Access Compliance Report Public Rights-of-Way (Curb Ramps)

Main Street: **BRENAN_WAY** Cross Street: **17TH_ST** Location: **SW**

ADA ID: **RPRK211007123021** Ramp Type: **Type 7 - Directional 2** Initial Pass/Fail: **Fail** Overall Compliance: **No** Severity Score: **15**

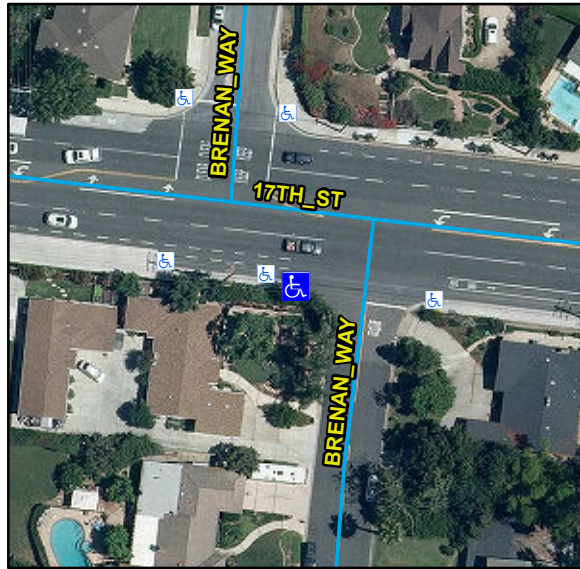
Compliance	Description	Data	Compliance	Description	Data
N/A	Ramp Length (in)	144	N/A	Flare Type LT	
Yes	Ramp Width (in)	50			N/A
No	Ramp Run Slope (%)	11.4	N/A	Flare Slope LT (%)	N/A
Yes	Ramp Cross Slope (%)	1.2	N/A	Flare Traversable LT	N/A
N/A	Grade Break	N/A	N/A	Flare Type RT	
N/A	Grade Break Slope (%)	N/A			N/A
N/A	Grade Break Cross Slope (%)	N/A	N/A	Flare Slope RT (%)	N/A
	Addl Para Ramp Left?	No	N/A	Flare Traversable RT	N/A
	Addl Para Ramp Right?	No	N/A	DWS Provided	N/A
N/A	Landing Present	N/A	N/A	DWS Contrast	N/A
N/A	Landing Length (in)	N/A	N/A	DWS Length (in)	N/A
N/A	Landing Width (in)	N/A	N/A	DWS Full Width	N/A
N/A	Landing Run Slope (%)	N/A		DWS Offset Type	N/A
N/A	Landing Cross Slope (%)	N/A	N/A	DWS Left Offset (in)	N/A
N/A	Landing Movement Obstructed?	N/A	N/A	DWS Right Offset (in)	N/A
	Landing Movement Type	N/A			
N/A	Landing Shared	N/A			
N/A	Marked Crosswalk 1	No	N/A	Clear Space	N/A
	Crossing 1 Direction	E	N/A	Clear Space To Crosswalk (in)	N/A

Remove & Replace Entire Ramp.
